Application of Mustaq Moosa for a Special Land Use Permit (SLUP) to allow fuel pumps as an accessory use in the C-1 (Local Commercial) District, at 1762 Panola Road.

PETITION NO: N16. SLUP-21-1244547 2021-2123

STAFF ANALYSIS

| Case No.: | SLUP-21-1244547 | | Agenda #: N-16 |

MATERIAL LEGEND

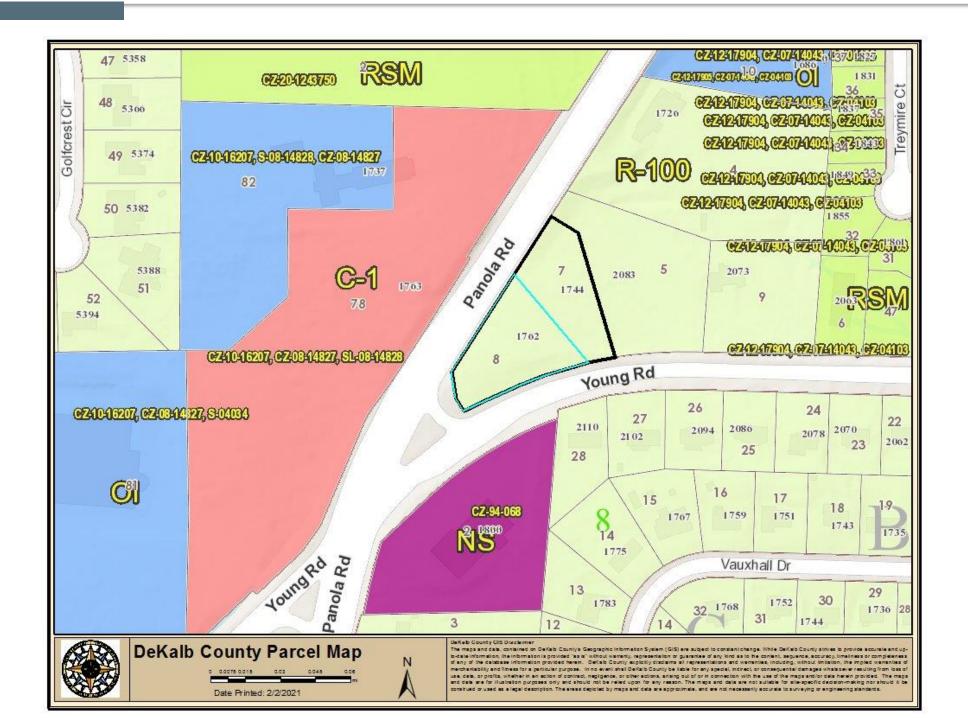
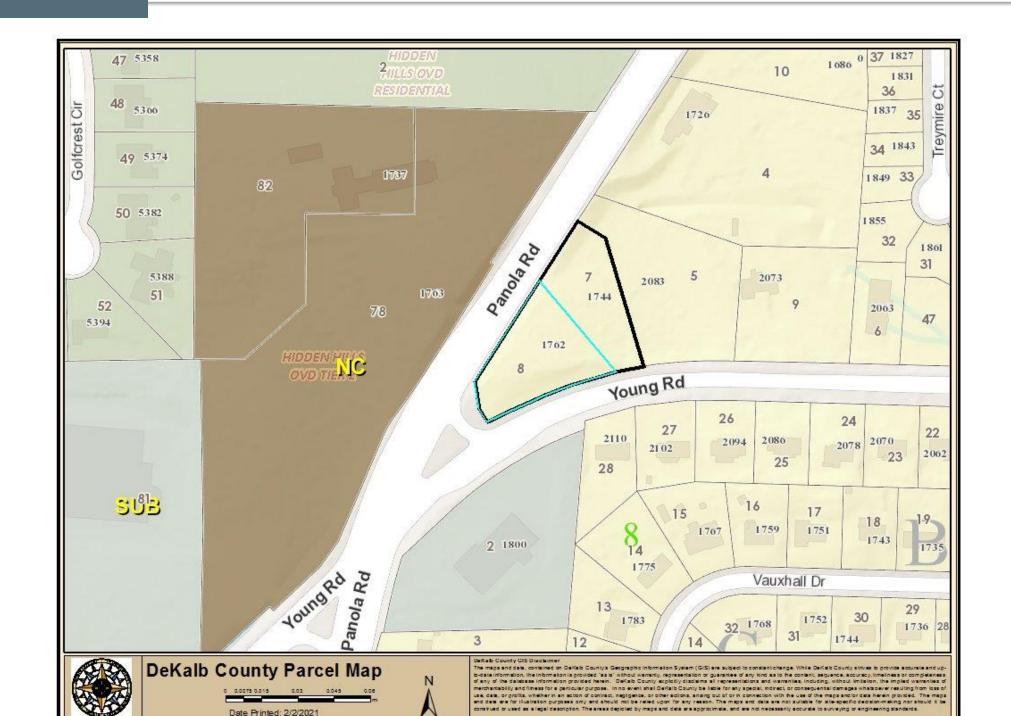
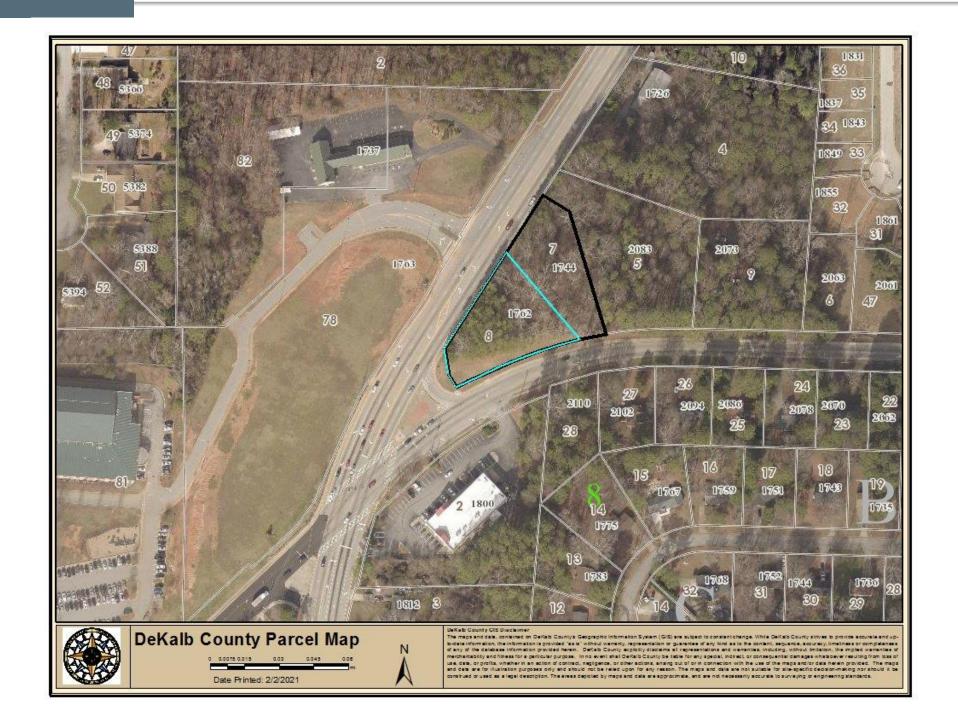
| | STANDARD | C-1 REQUIREMENT | EXISTING/PROPOSED | COMPLIANCE |
|---------------|--------------------|---|--|---|
| E | BUILDING MATERIALS | All building facades facing a public street shall consist of at least 80% brick, stone, glass, decorative concrete, fiber cement siding, or hard coat stucco, or combination thereof. | Conceptual elevations appear to demonstrate compliance. | YES. |

- 3. Buildings shall be similar to the submitted conceptual elevations.
- 4. Provide landscaping, sidewalks, and street trees along Panola Road and Young Road as required by Article 5 of the zoning ordinance. Provide a two (2) foot high masonry wall with landscaping and/or an evergreen hedge to help screen the pumps from view from a public right of way.

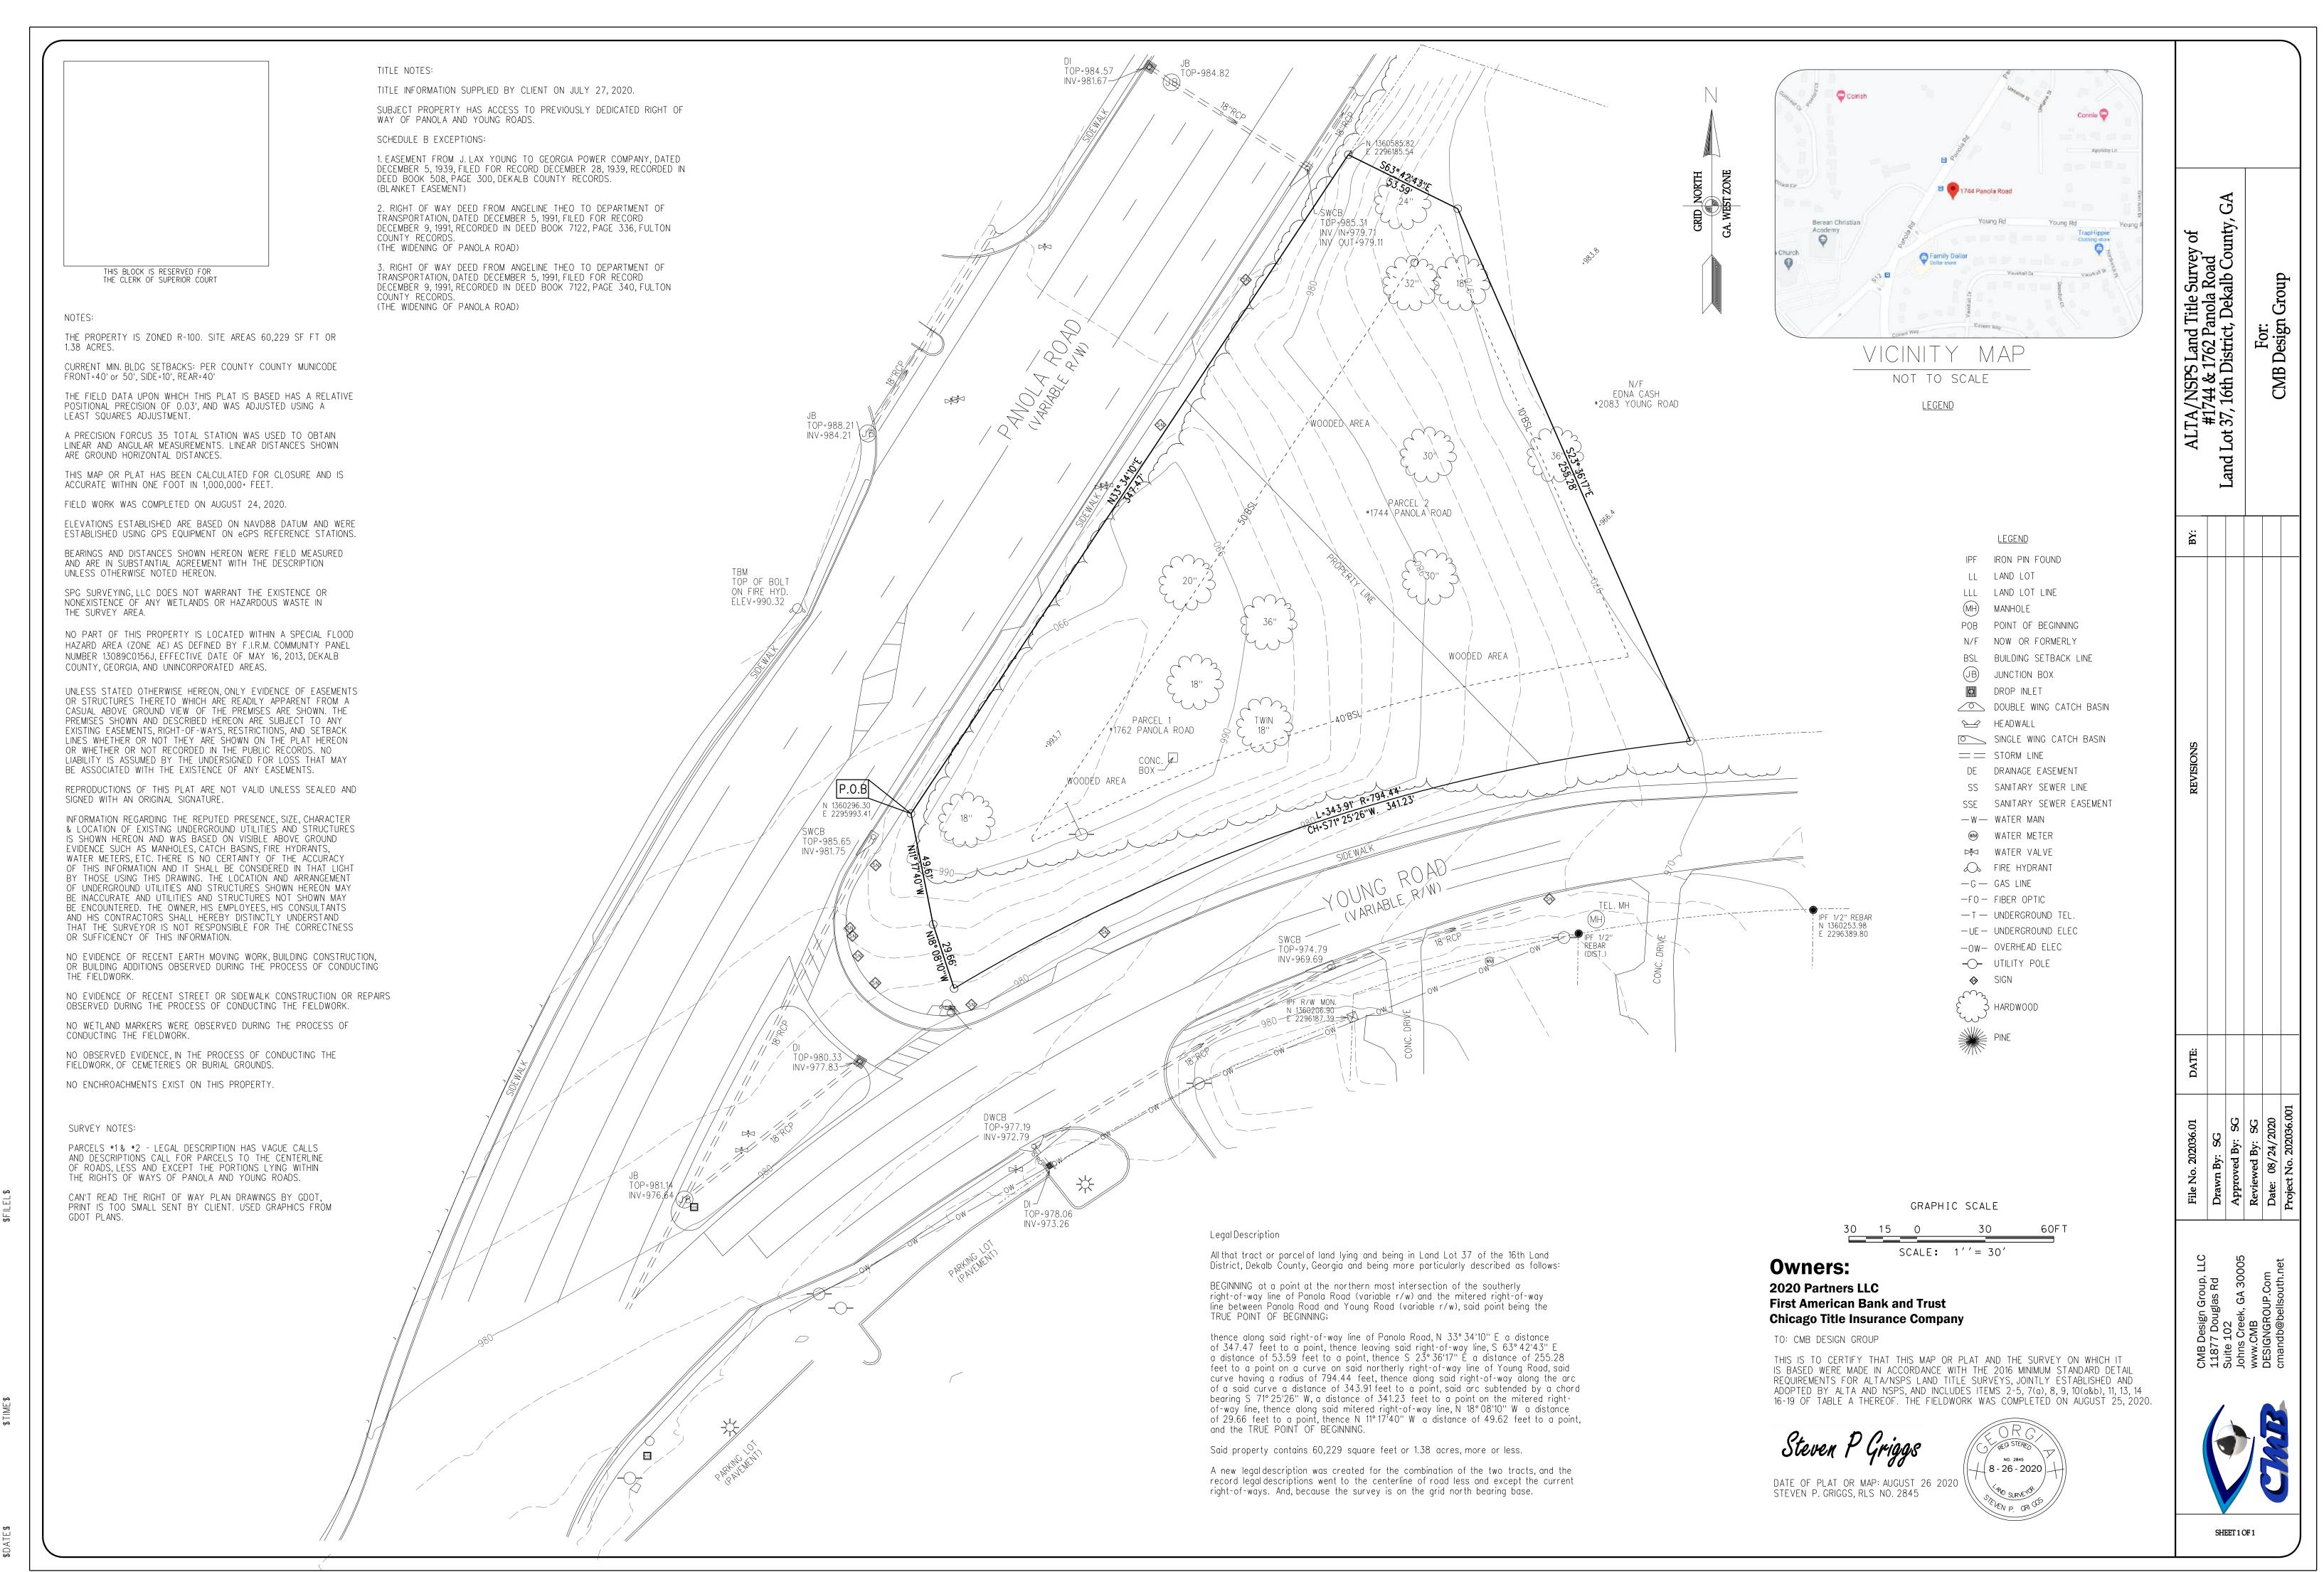
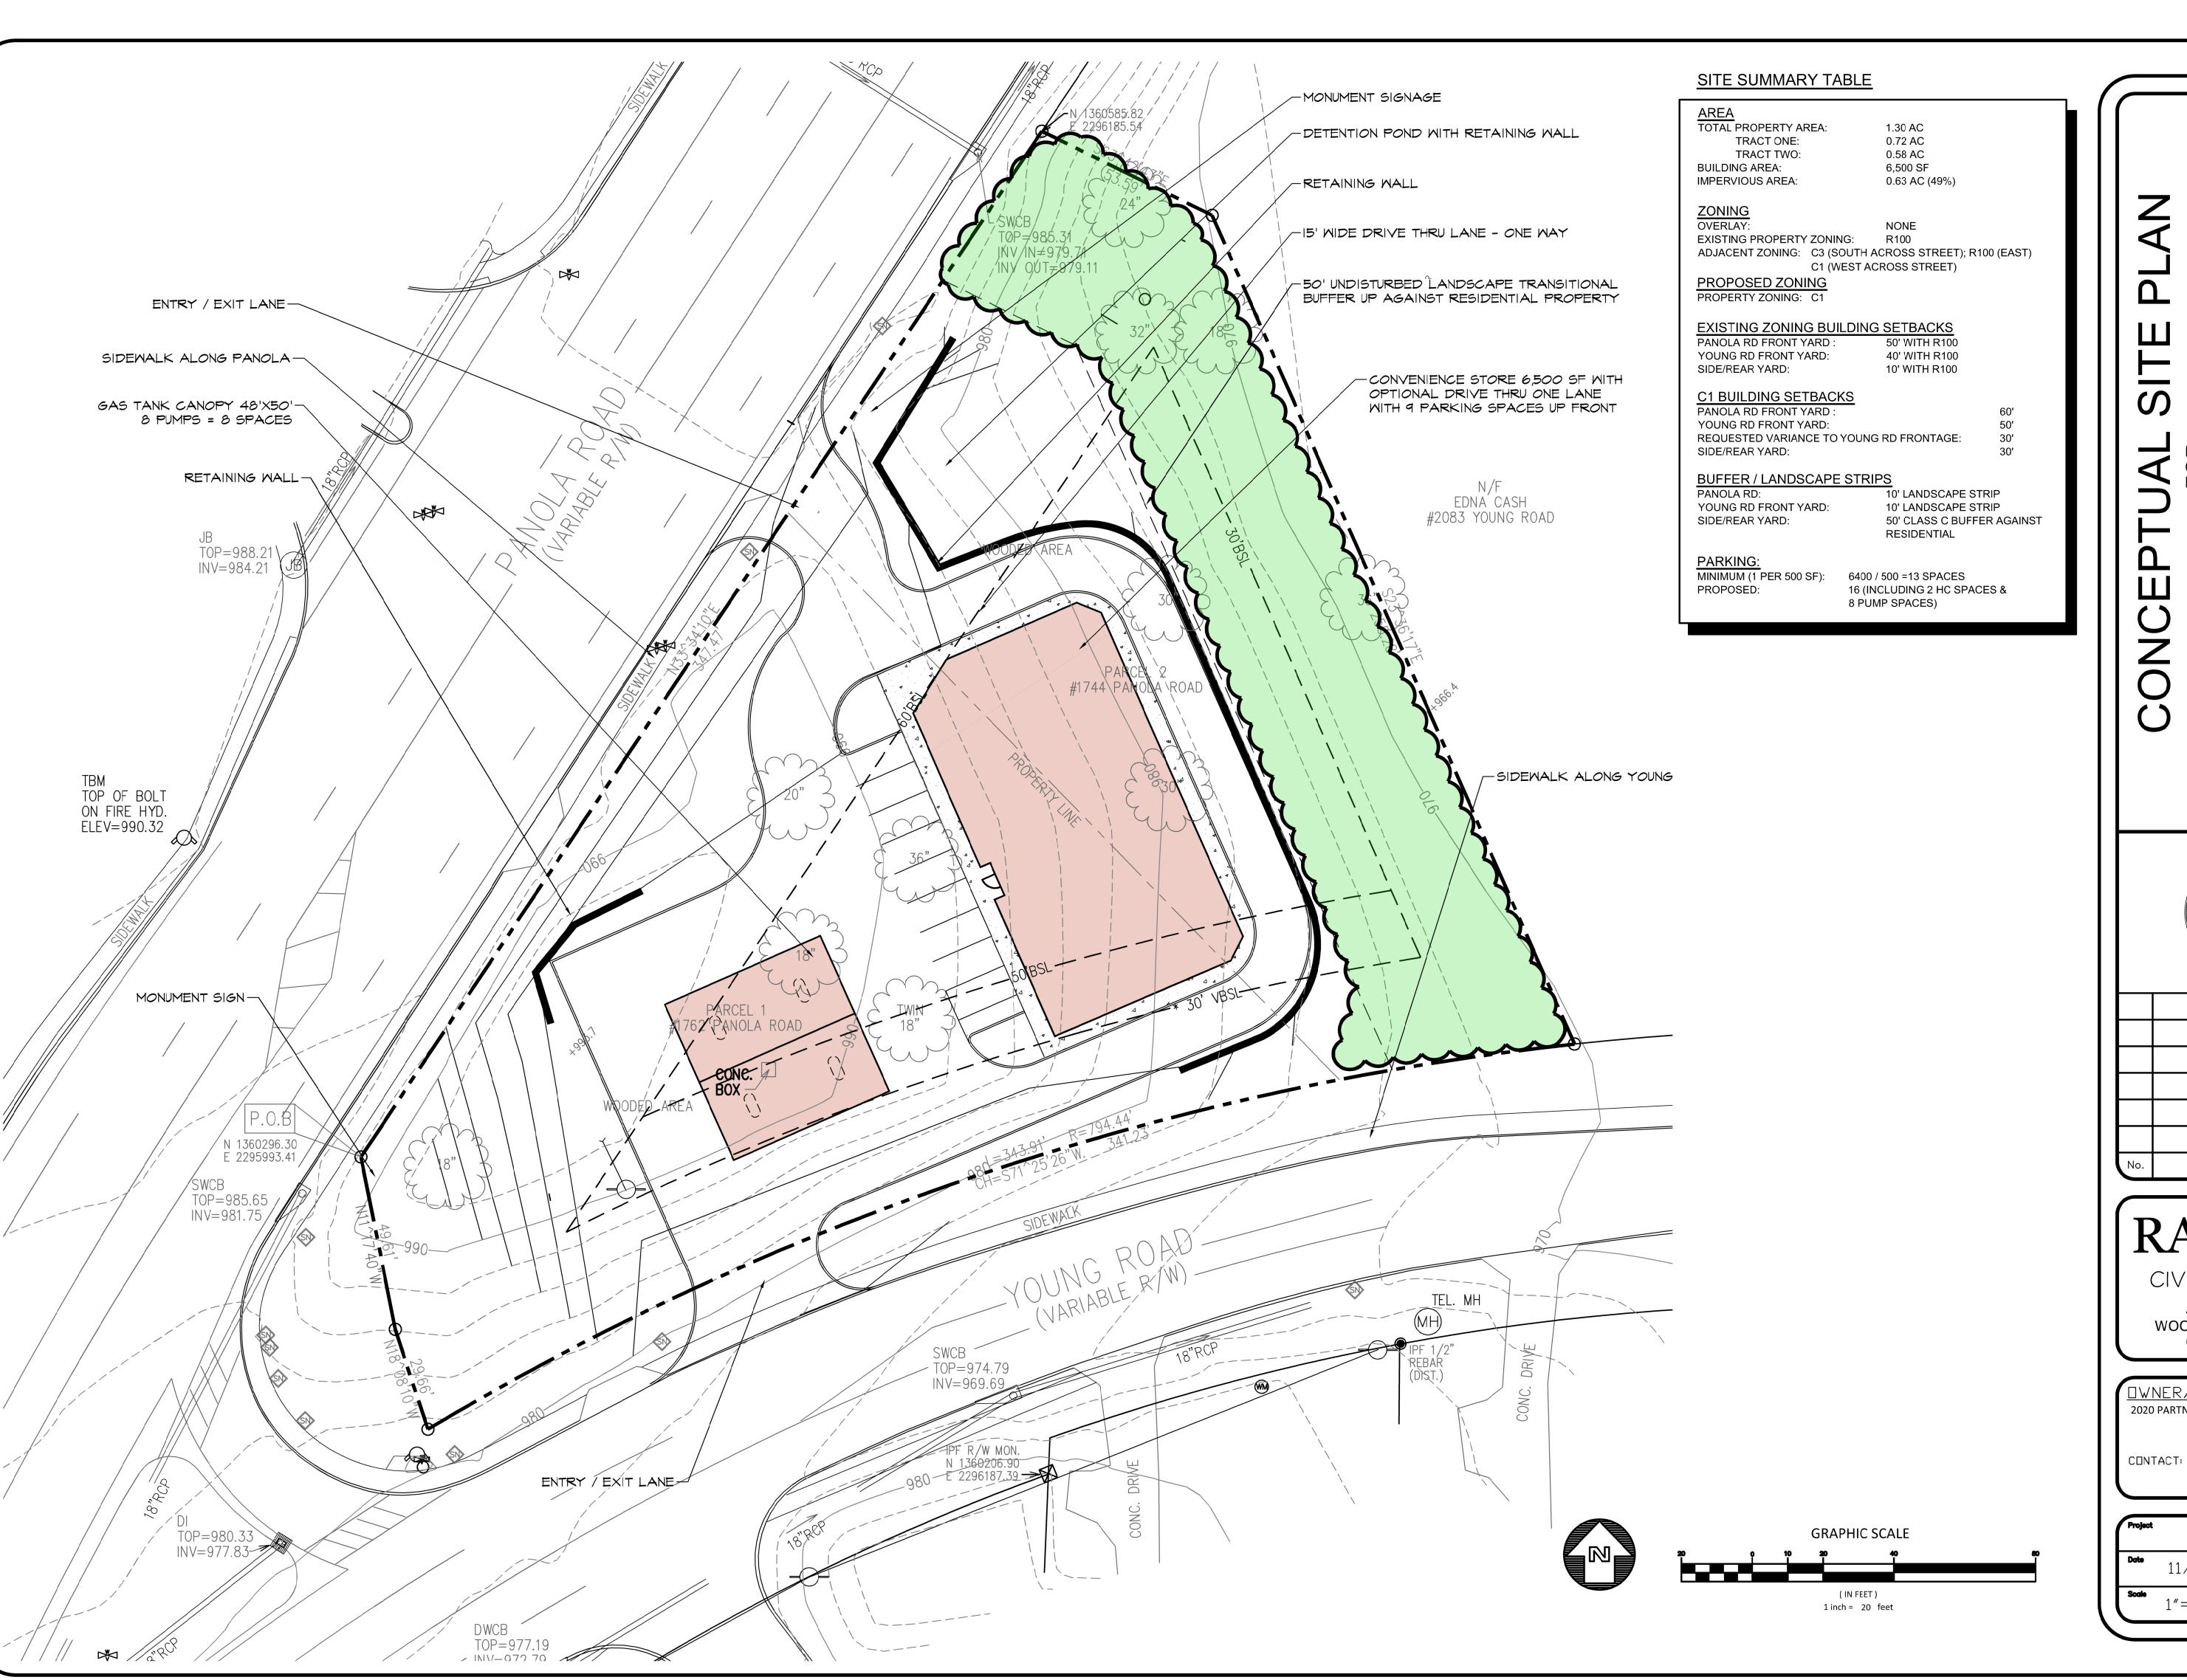
The site plan shows a retaining wall to be constructed along the north and eastern portion of the site, but the height of that retaining wall is not indicated. Retaining walls are limited to ten feet in height, unless a variance is obtained by the Board of Zoning Appeals. The site plan also shows an access drive around and behind the proposed building to facilitate safe and convenient ingress and egress within the site. The site plan does not indicate if this access drive will be used as a drive-through lane for a drive-through restaurant in the future. If a drive-through restaurant is proposed in the future, a Special Land Use Permit (SLUP) application shall be required to be submitted and approved by the Board of Commissioners.

| | STANDARD | C-1 REQUIREMENT | EXISTING/PROPOSED | COMPLIANCE |
|---------------|--------------------|---|--|---|
| YARD SI | | 50 feet (Young Road) | 30 feet | NO. Non-compliance will necessitate variances from the Board of Zoning Appeals. |

| MAX LOT COVERAGE | 80% | 50% | YES |
|--|--|--|--|
| SIDEWALKS AND STREETSCAPING | 6-ft. sidewalk and 10-ft landscape strip along Panola Road and Young Road, with street trees every 50 feet on center. Internal sidewalks required to connect the building to public sidewalks along Panola and Young Road. | Sidewalks are proposed along Panola Road and Young Road. No landscape strips or street trees shown. No internal sidewalks shown on plan. | YES for sidewalks. Undetermined for 10-ft wide landscape strip and street trees 50 feet on center. No internal sidewalks shown on plan. (Non-compliance will necessitate variances) |
| PARKING LOT LANDSCAPING | One tree for every 8 parking spaces; one tree island for every 10 parking spaces | No trees or tree islands are shown for the nine proposed parking spaces in front of building. | No. Non-compliance shall necessitate variances. |

| <u>STANDARDS</u> | COMPLIANCE | |
|---|---|--|
| Canopy height shall not exceed the greater of twenty (20) feet or the height of the principal building | Undetermined. Information not provided on plan. Non-compliance will necessitate variances. | |

Since a building setback variance is requested off of Young Road for the convenience store associated with the proposed fuel pumps, approval cannot be based on the submitted concept plan. Approval of this rezoning application by the Board of Commissioners has no bearing on other approvals by the Zoning Board of Appeals or other authority, whose decision should be based on the merits of the application before said authority. The Department of Planning and Sustainability recommends "Approval" with the following conditions:

- 1. Not based on submitted site plan. Allow up to eight accessory fuel pumps in conjunction with a convenience store and retail uses.
- 2. Provide a 50-foot wide undisturbed transitional buffer along the eastern property line. Existing trees within the 50-foot transitional buffer shall be preserved and supplemented with new trees (if necessary) to form an effective visual screen as approved by the County Arborist prior to the issuance of any Certificates of Occupancy.
